# **AGENDA**

**REDEVELOPMENT AUTHORITY  
OF THE CITY OF STEVENS POINT**

***Onsite Masonry Veneer Evaluation***

Edgewater Manor  
1450 Water Street  
Stevens Point, WI

Photo No. 11- The brick tie adjacent to the dislodging veneer is being pulled away from the wall

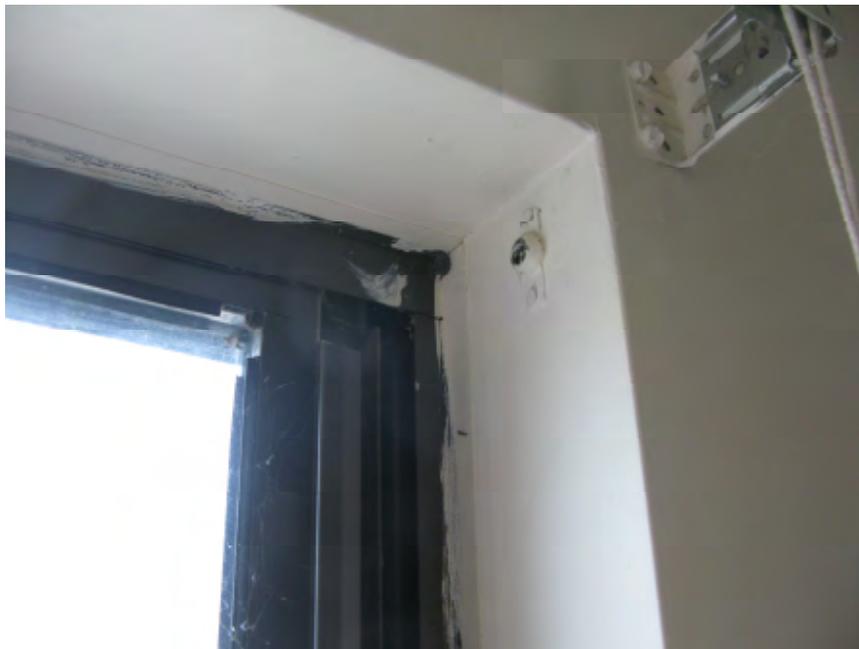
- Bedroom window exterior sill flashing has rotated upwards (Photo Nos. 1 & 2).
- Perimeter sealant around the windows has failed cohesively (Photo Nos. 1, 3-5).
- A straight edge was set against the wall to evaluate the offset of the dislodged brick (Photo No. 6).
- Window assembly has settled approximately  $\frac{1}{4}$ - $\frac{3}{8}$ " (Photo No. 7).
- There is a significant amount of mortar droppings behind the brick veneer, there is no mortar netting (Photo No. 8).
- The windows are sealed to the brick veneer; there is no weather barrier behind the veneer (Photo No. 9).
- Water staining is present below the window corners on the exterior sheathing (Photo No. 10).
- Some of the galvanized masonry veneer anchors are being pulled away from the wall as the brick veneer is dislodging (Photo No. 11).

Photo No. 15- Control joint at steel shelf angle (sealant removed)

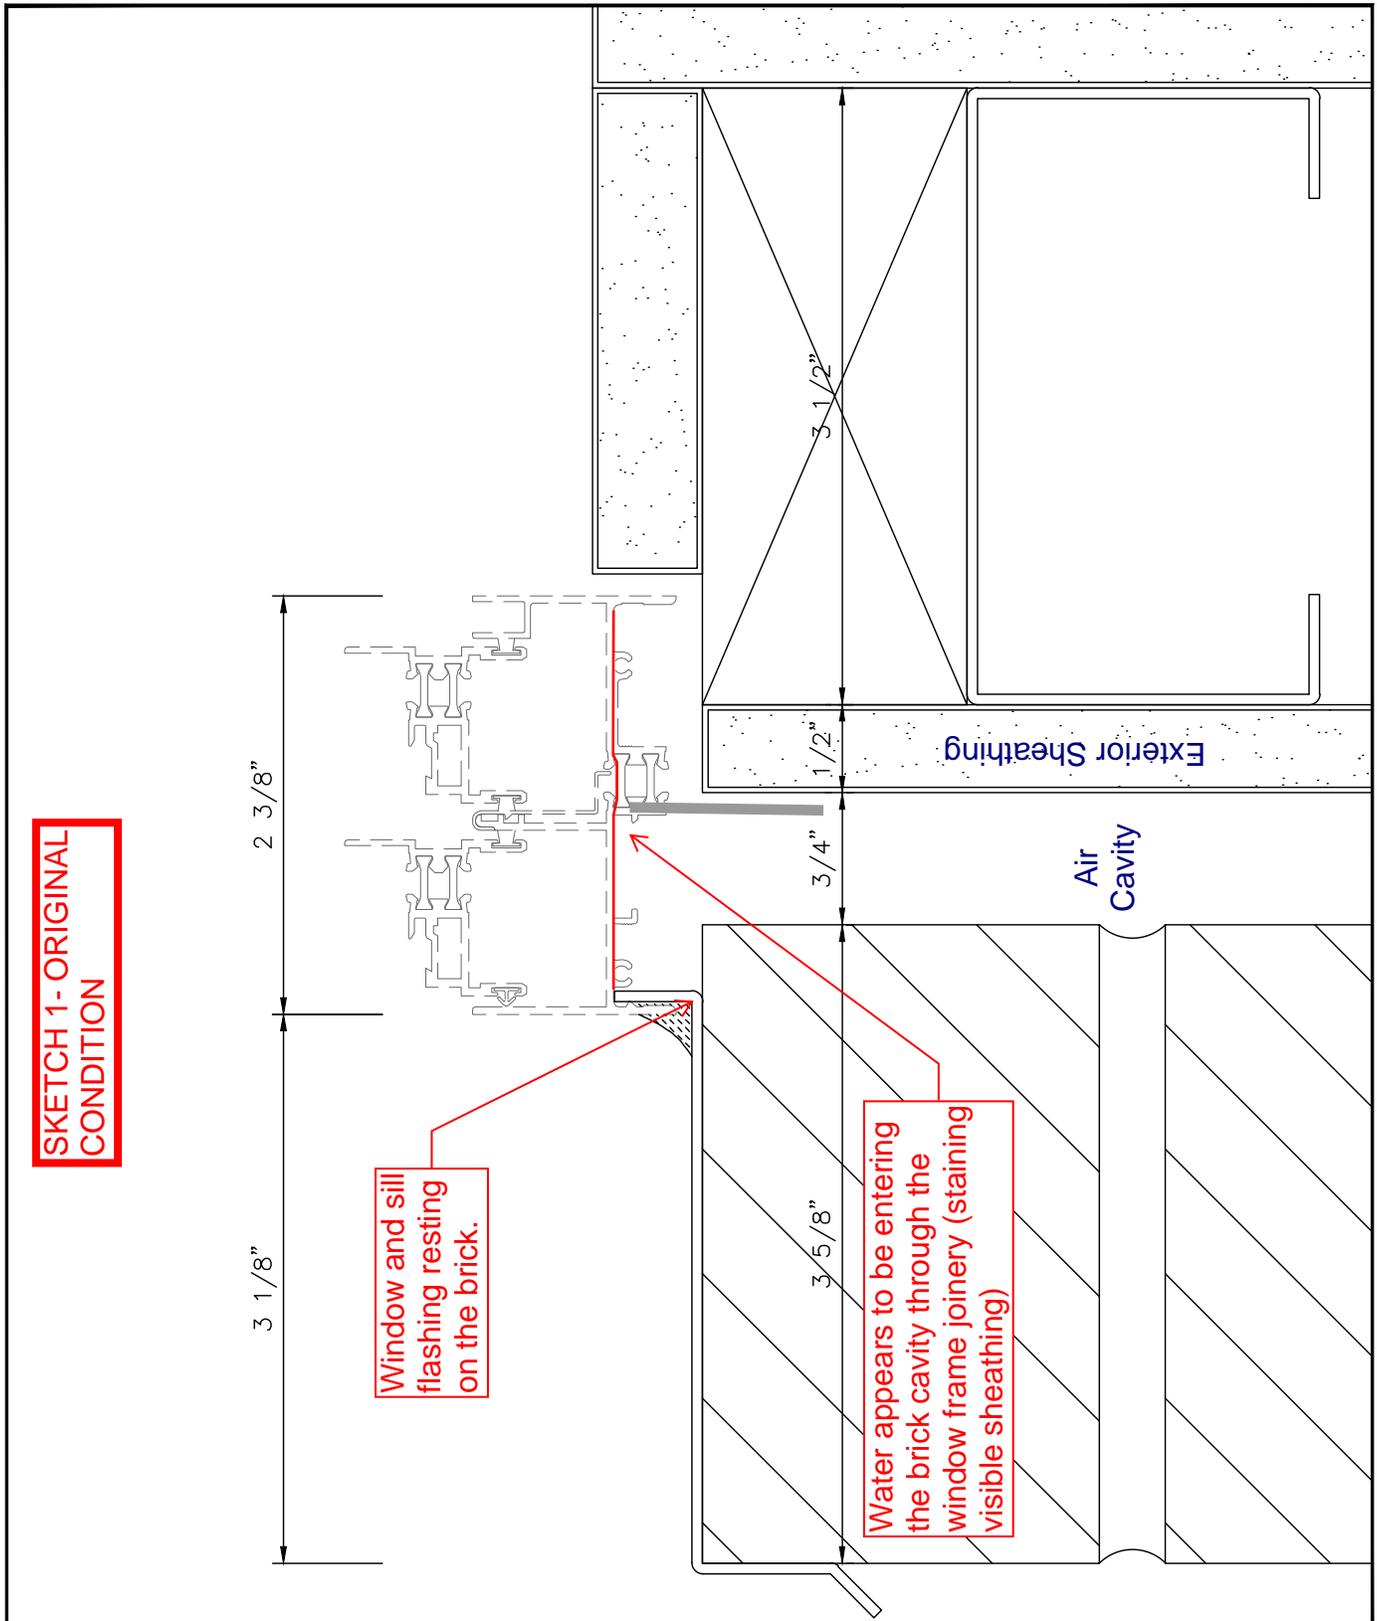
- There are no current signs of movement or damage to the interior finishes (Photo Nos. 12-14).
- The steel shelf angle is concealed by the horizontal control joint sealants (Photo No. 15).
- The masonry veneer wall assembly is constructed from exterior to interior as follows:
  - Brick veneer
  - Air cavity
  - Exterior sheathing board
  - Metal stud framing with batt insulation set on top of the floor slab
  - Interior drywall

The original design indicates the wall flashing one course above the control joint, as constructed the flashing is set directly on top of the steel shelf angle; exterior of the steel shelf angle between the brick is a control joint (sealant) with rope wicks. The rope wicks cannot efficiently drain the water entering the brick cavity as the water flow is blocked by the control joint sealant (reference Sketch 3). This detail is present at all shelf angles around the building. We suspect that some locations are able to drain back into the cavity below or have little mortar droppings which may be why these areas are not currently displacing.

Sheet No.: D1  
Job Number:  
**13082**

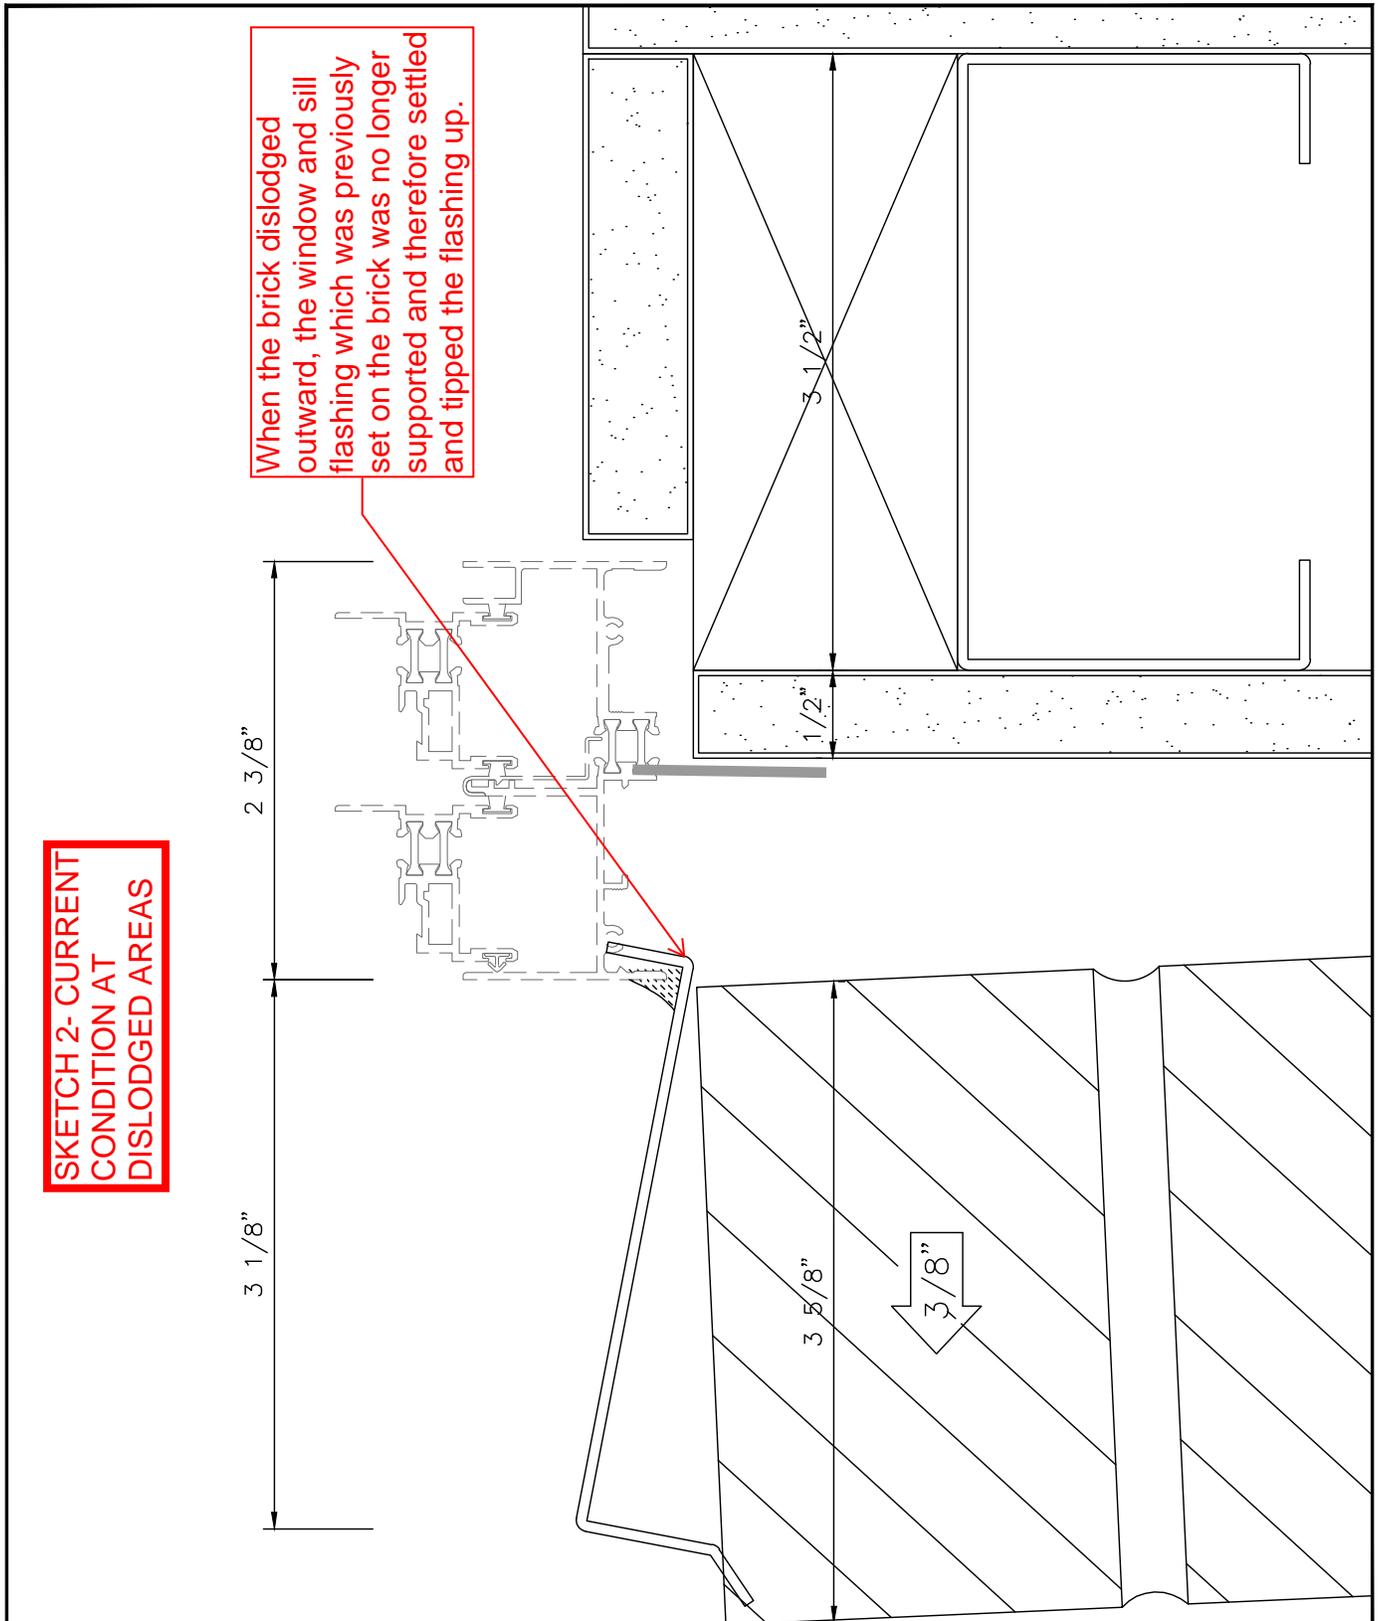
As a direct result of the displaced brick veneer at various locations the window assembly and exterior sill flashing which previously set on the inner edge of the brick (reference Sketch 1) are no longer supported by the brick allowing the window to settle slightly tipping the flashing upward (reference Sketch 2) and causing the window sealants to tear or fail cohesively. With the sill flashing back-pitched and the window perimeter sealants failing there is the reality of increased potential for water entry into the air cavity which again cannot be effectively drained further aggravating the root cause.

Window and sill  
flashing resting  
on the brick.

Water appears to be entering  
the brick cavity through the  
window frame joinery (staining  
visible sheathing)

Sheet No.: D2  
Job Number:

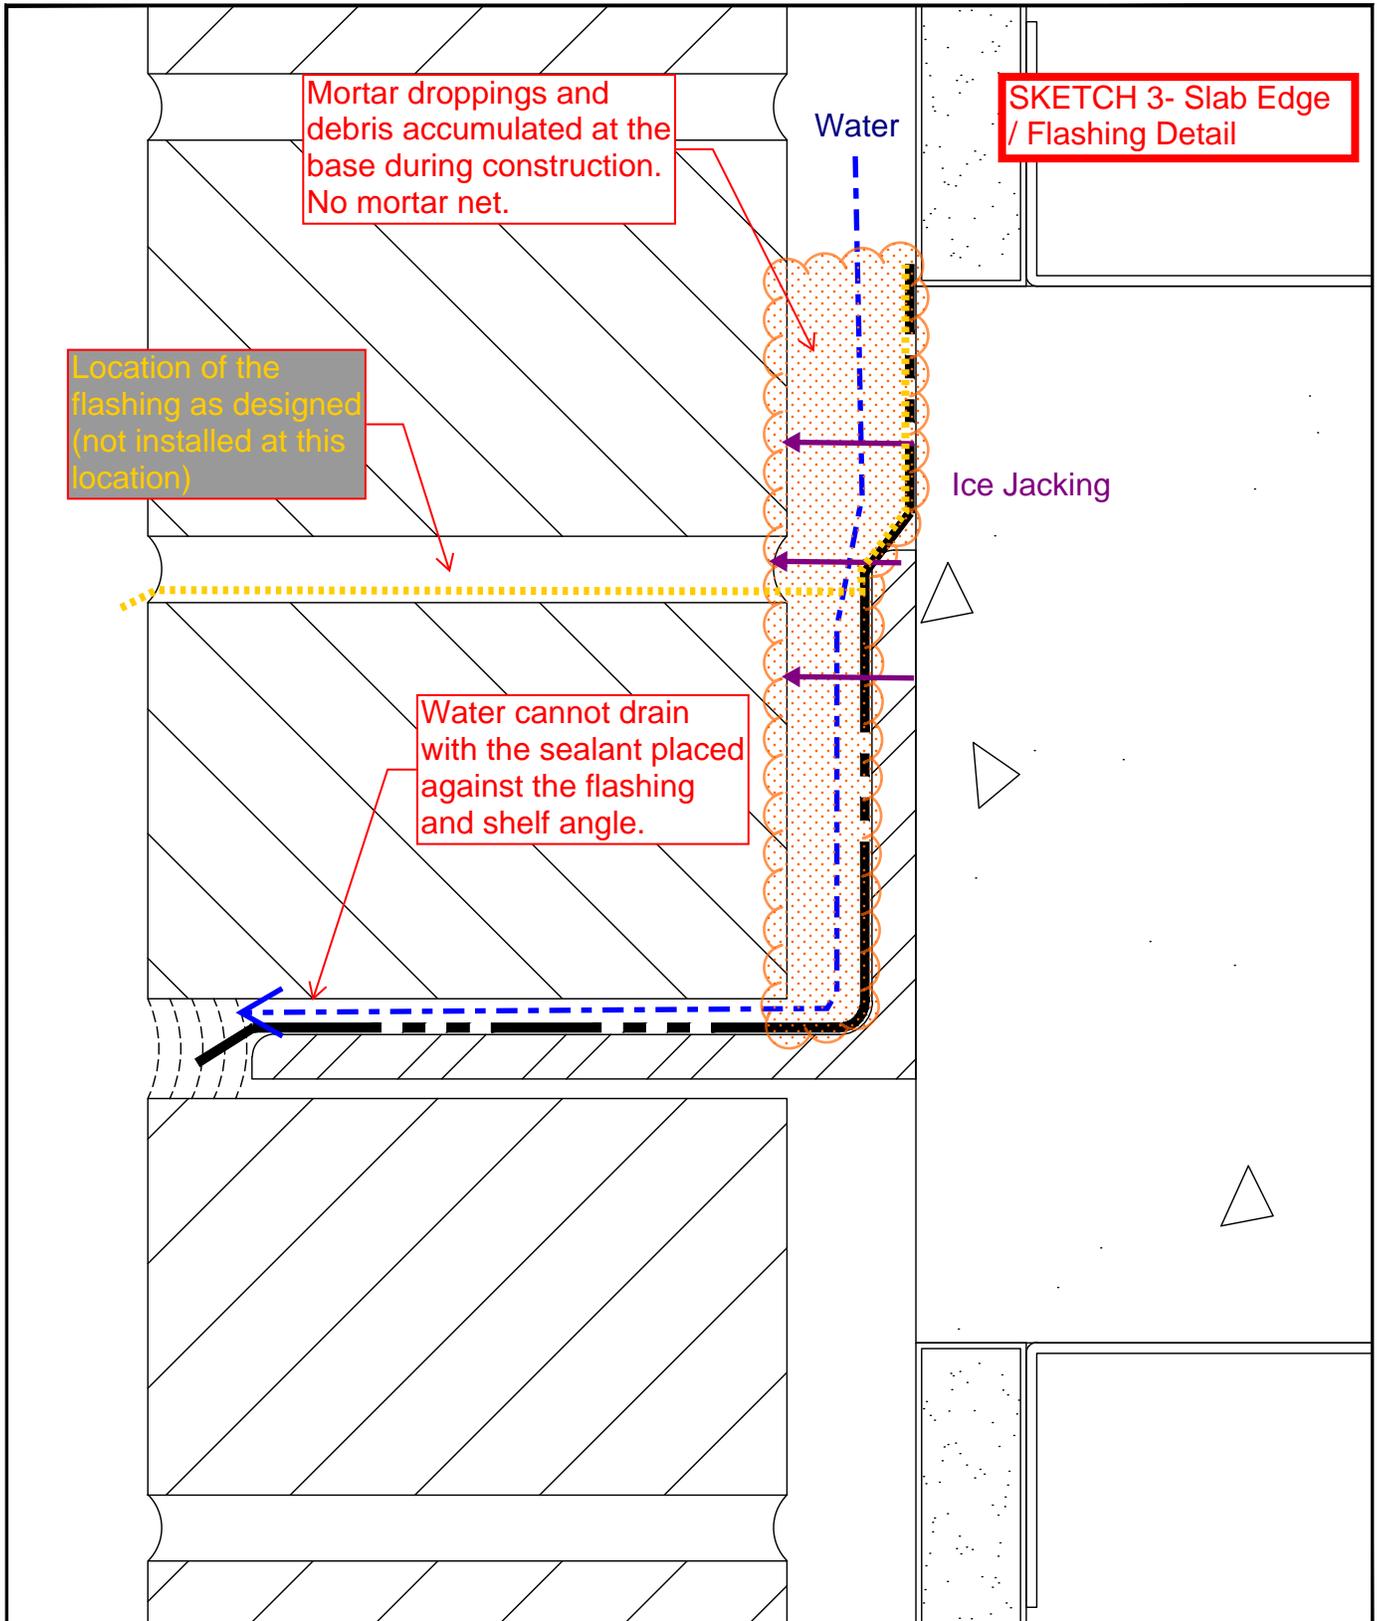
The masonry veneer wall assembly is designed and intended to take on minimal water volume and divert that water back to the exterior of the wall assembly. Based on the sample cuts performed on November 26, 2013 it was apparent that the drainage of water from the air cavity was severely hindered due to significant amounts of mortar droppings and the inability for the flashing to effectively drain. We believe the most significant mechanism contributing to the brick displacement is freezing water trapped or contained within the air cavity at the base of the flashing. The combination of mortar droppings and water accumulation due to limited drainage has permitted “ice jacking” between the shelf angle or slab edge and the interior side of the brick veneer (reference Sketch 3); over time more water will be permitted due to failing sealant and window joinery issues.

We have considered performing limited renovations to the failing areas; however we cannot guarantee that this process will not continue to occur at other areas. If desired we are willing to discuss this option further but do not believe that is a good long-term option; our opinion regarding this is based on the in-ability for the flashings to effectively drain (depicted on Sketch 3).
